LANDMARK COMMISSION

FILE NUMBER: COA-26-000122
LOCATION: 3919 Waldron Ave.
STRUCTURE: Non-Contributing
COUNCIL DISTRICT: 7
ZONING: PD-595

Courtesy Review (CR): Construct a new main residential building (on a vacant lot) with a rear detached two car garage.

TASK FORCE RECOMMENDATION REPORT
WHEATLEY PLACE / TENTH STREET / QUEEN CITY

01 EAST SIDE ELEVATION
1/4" = 1'-0"

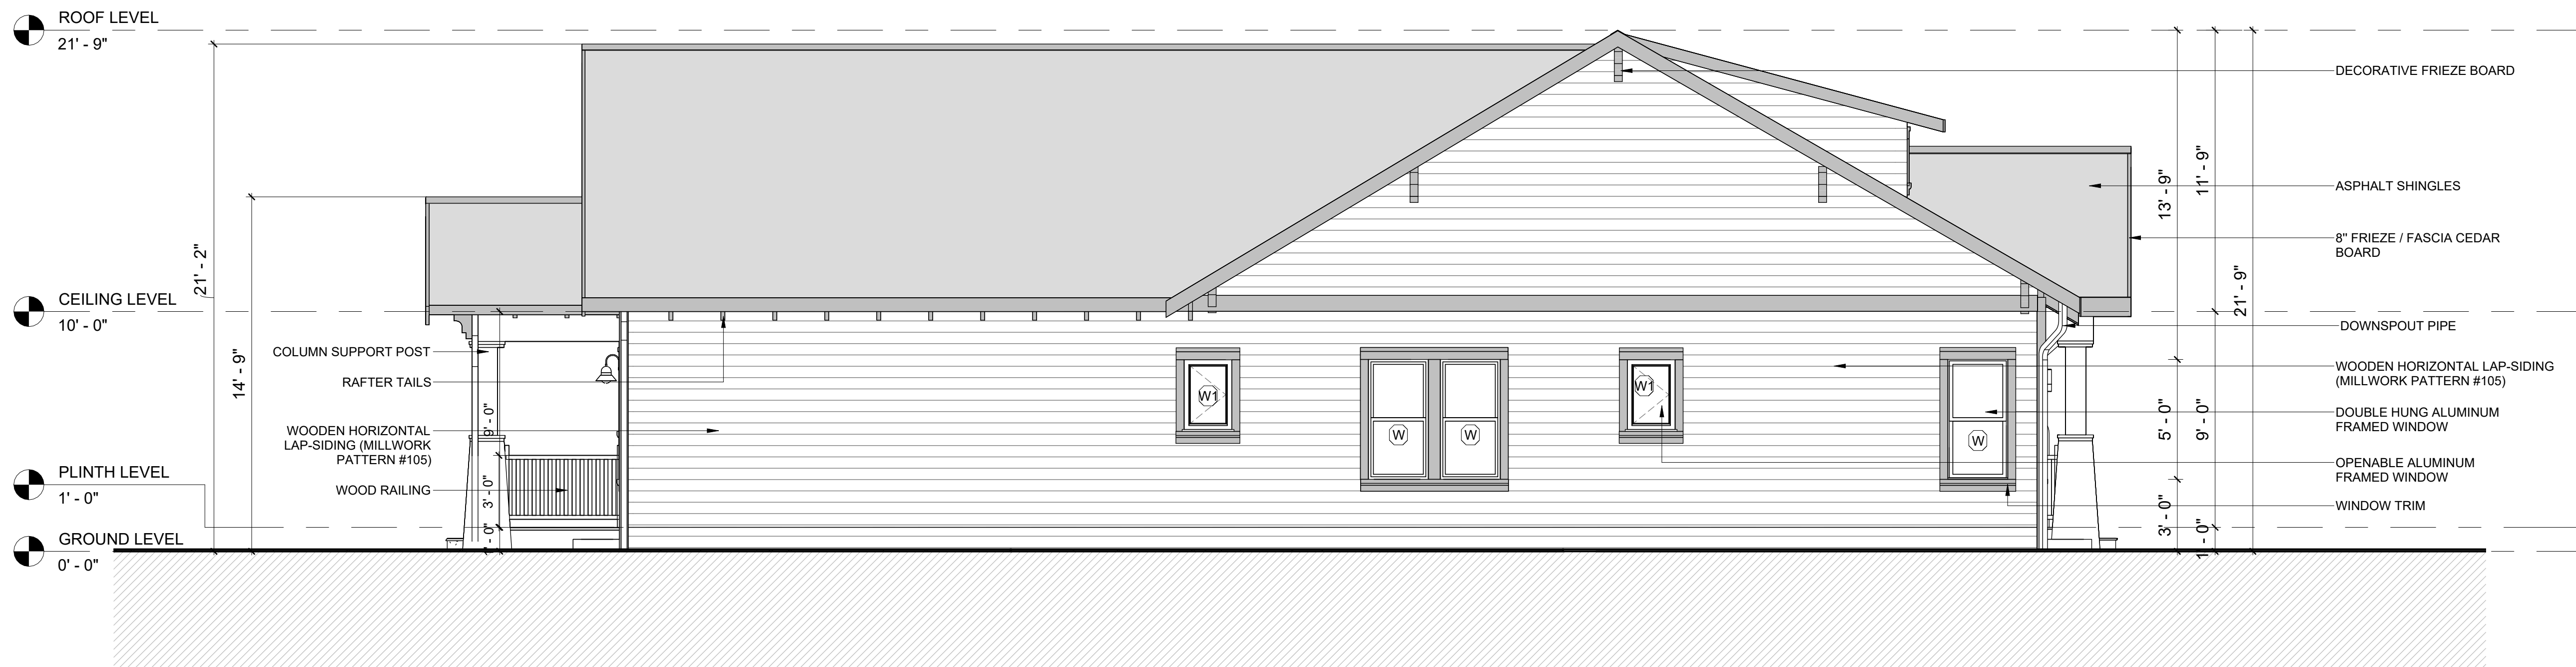
1. The front dormer is too high up, on the front roof slope.
2. Windows of the dormer are too short.
3. Driveway appears to encroach on the neighbor's property.
4. Reduce the width of the driveway – too much hardscaping, not enough green space.
5. Two-part porch columns on front and rear porches should have square/rectangular bottoms, not flared.

SHEET NAME :
FOUNDATION DETAILS

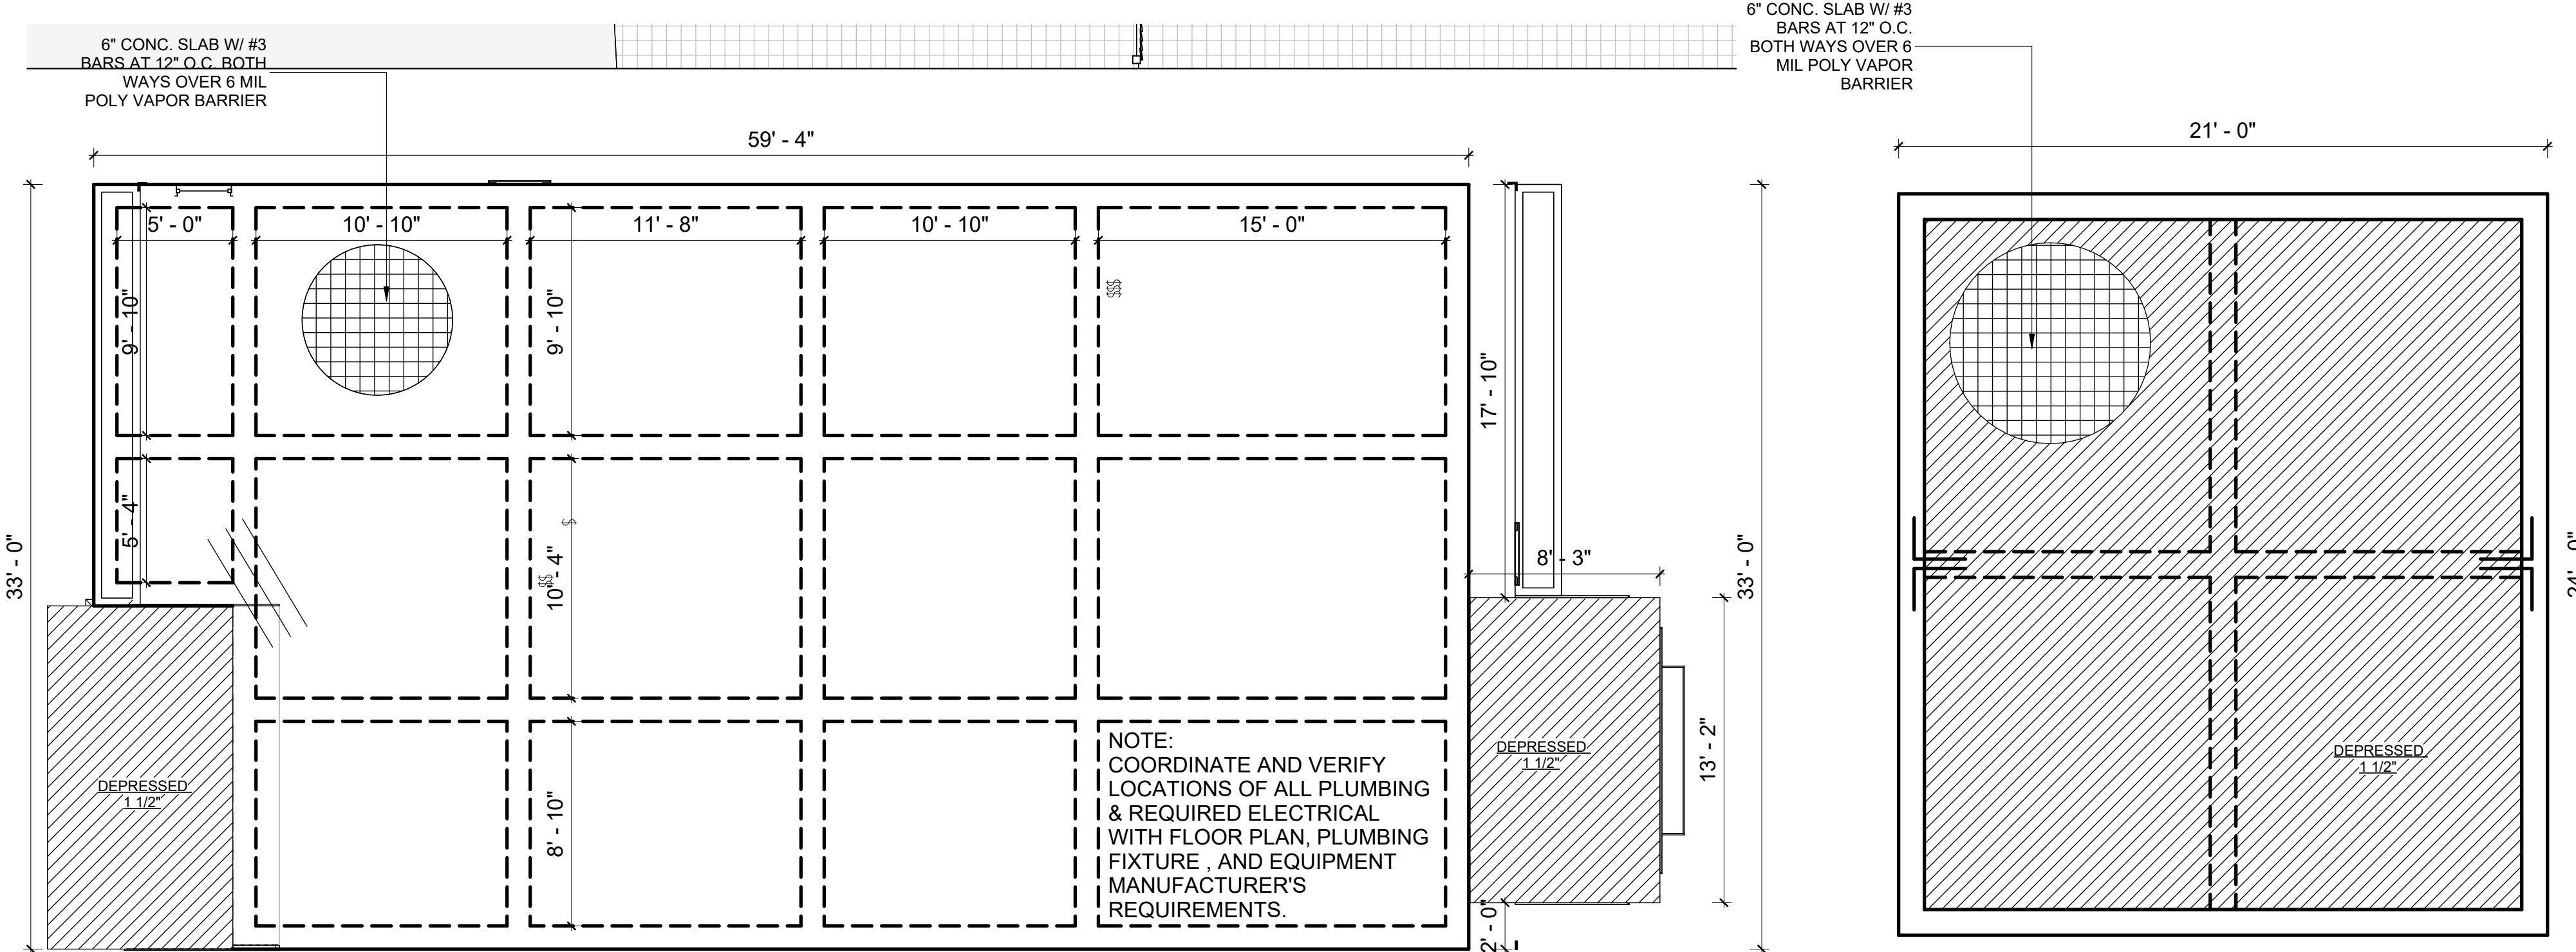
6. Porch column bottoms should be brick and sit on grade.
7. The foundation should be raised with a crawl space (minimum height 18 inches) or a pier and beam.
